Form 1 OPGP04-ZE-0309/R20		<b>DESIGN CHANGE PACKAGE (DCP)</b>				Page 1 of <u>13</u>									
DCP # 08-15484-2		Supp # 0	As-built: <input type="checkbox"/>	Trend Code: N/A	Unit: 2	System: RD									
Major Mod <input type="checkbox"/> JPR cert. 9017	Minor Mod <input type="checkbox"/> JPR cert. 9017	MC Enhancement <input type="checkbox"/> JPR cert. 9016	MC Other <input checked="" type="checkbox"/> JPR cert. 9016	Paper Chg <input type="checkbox"/> JPR cert. 9015	Admin <input type="checkbox"/>										
DCP Title: Rod Drive MG Set -Motor 21 Replacement				<u>32380365</u>											
TPNS / TAG #'s affected: 7Z172ERD101A				TPNS# continued on pg. <u>N/A</u>											
<b>DCP Scope Summary:</b> <b>Problem Statement:</b> While replacing the bearing for Rod Drive MG Set motors #1 and #2, small cracks were found in the red epoxy resin material between the stator bar slots of motor#1. Also, found some slots have the red epoxy resin material and some without it. In motor #2, red epoxy resin material found between the stator bar slots in a few places but no cracks were present. Contacted System Engineering for visual inspection. <b>Problem solution:</b> Replace the degraded motor (Westinghouse

## TORQUE & CIRRENT VS. SPEED

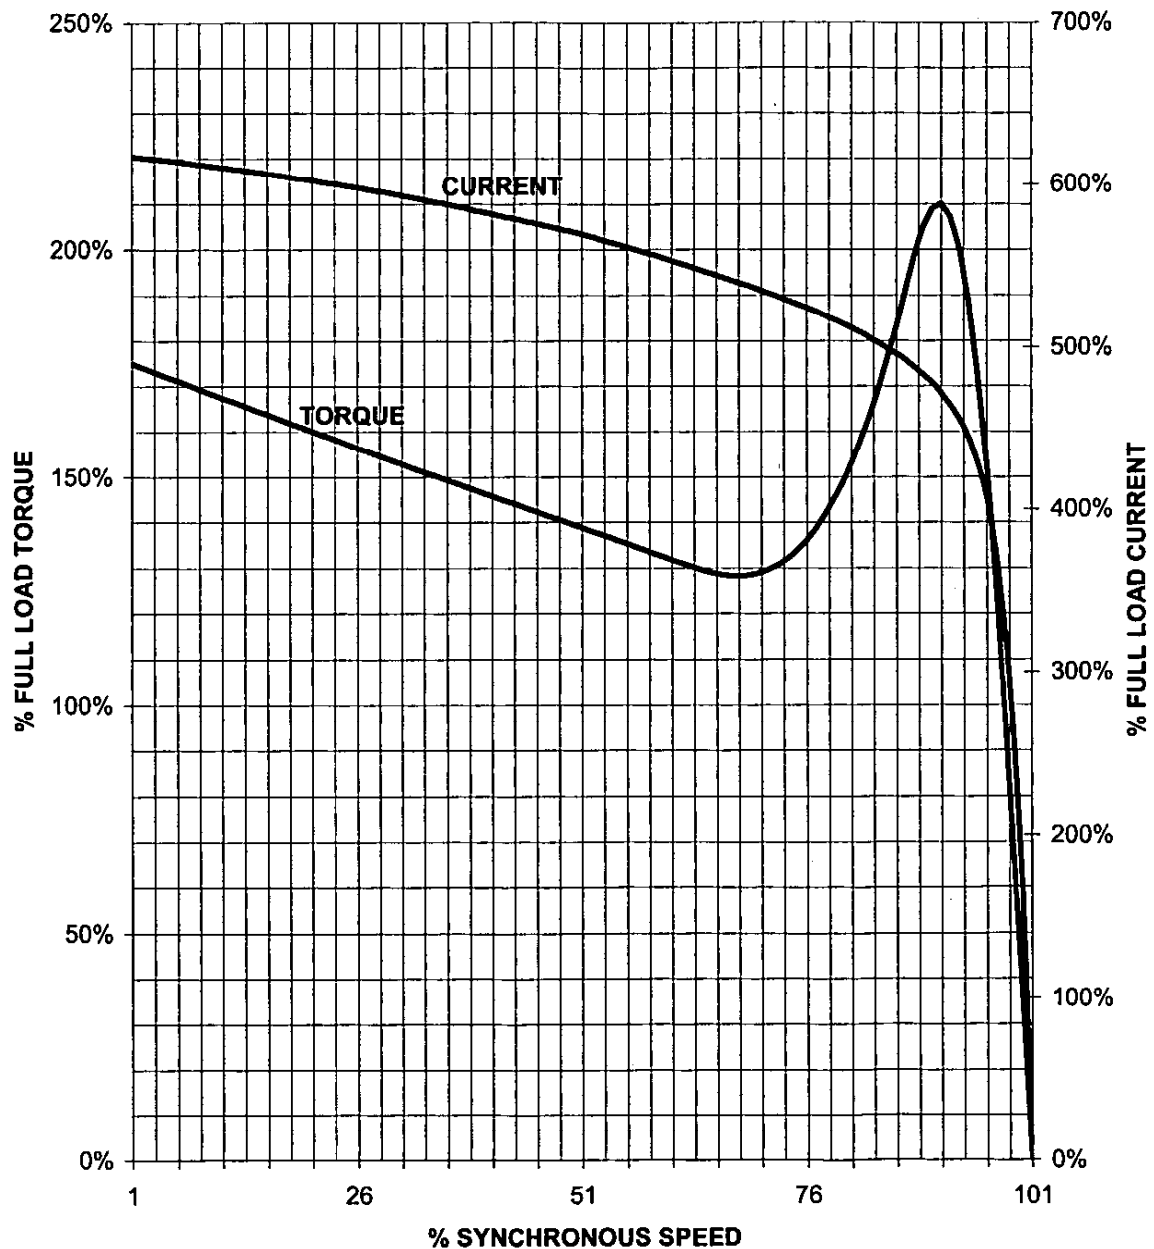
Per Siemens (Mary Harris at 1-800-654-8801), the Siemens RG motors have the same torque speed curves as the Siemens DP10 motors.

Attached is the Siemens DP10 torque speed curve for 200 hp 200hp 360vac 1800 rpm 60-hz 3-phase Frame 445 TS NEMA Design B motor which should be the same as our RG motor of the same rating.

NEW MOTOR

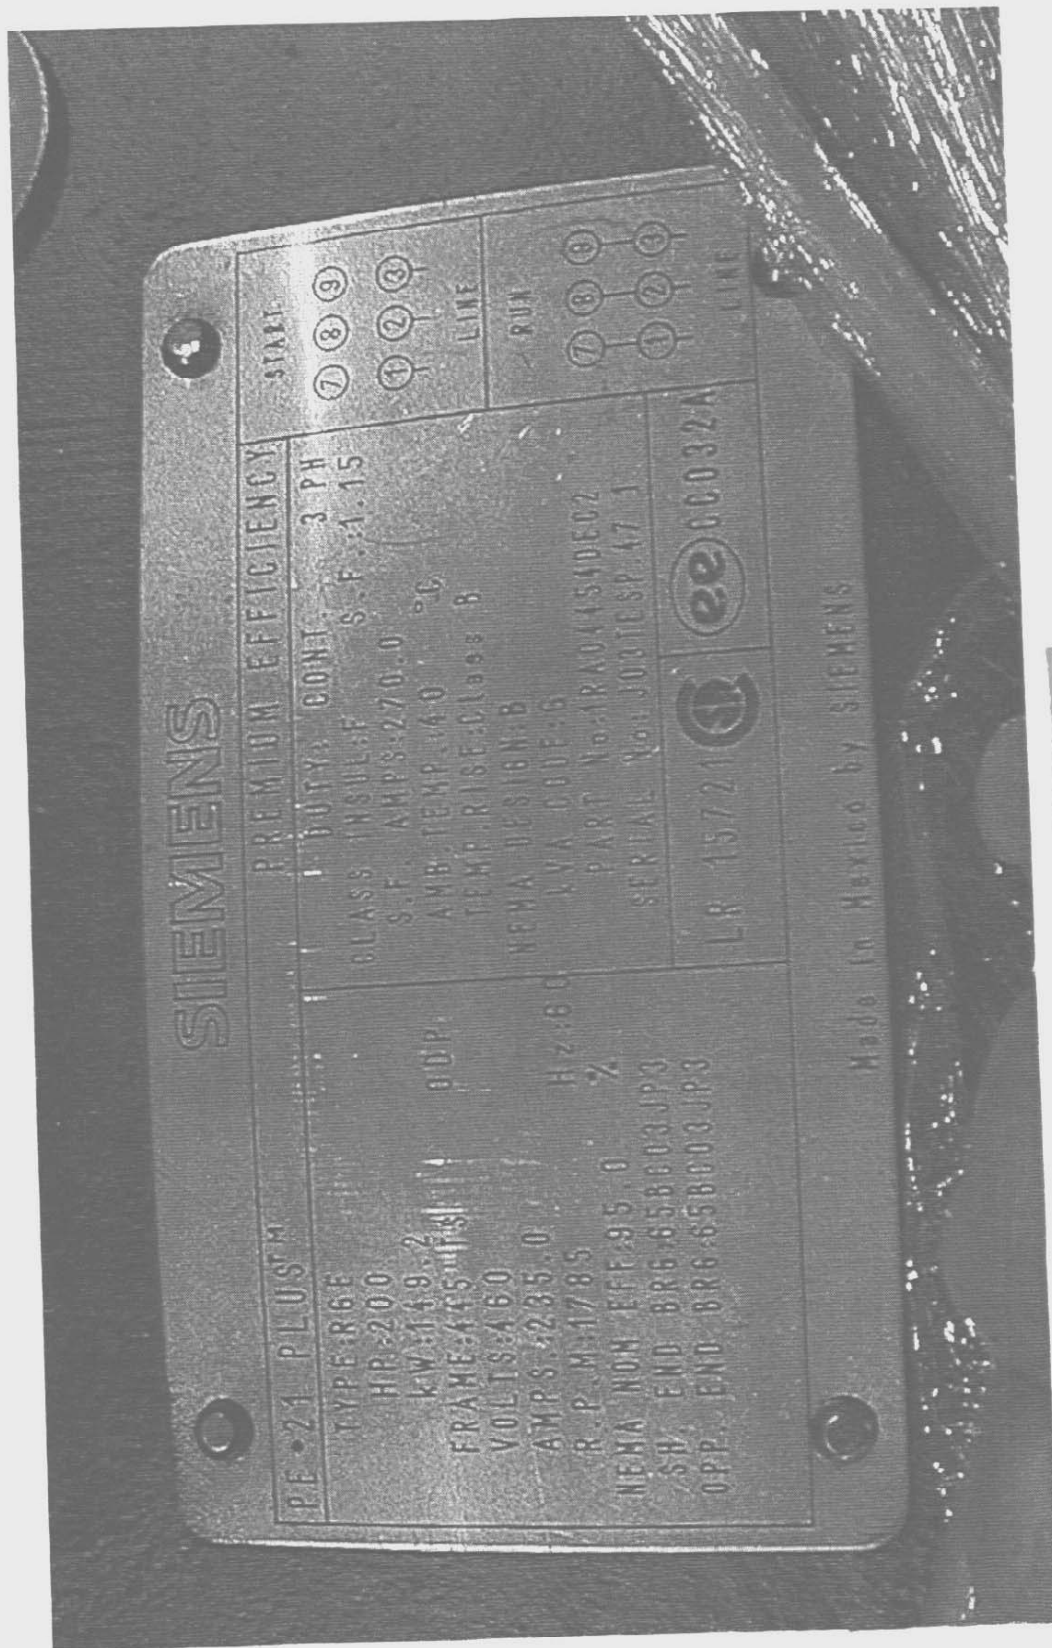
**NO.** the proposed activity is limited to replacing the existing motor (Westinghouse) with an equivalent motor (Siemens "RGE"). The new motor has critical characteristics that are equivalent to the existing motor. The torque speed curves for the new motor (RGE) are the same as the Siemens DP 10 motors. The breaker settings are not affected except for the instantaneous setting. This setting is increased from 3000A to 3600A to accommodate the increased inrush current for the new high efficiency motor and has no affect on breaker coordination with upstream devices. Therefore, the proposed activity does not involve a change to an SSC that adversely affects an UFSAR described design function.
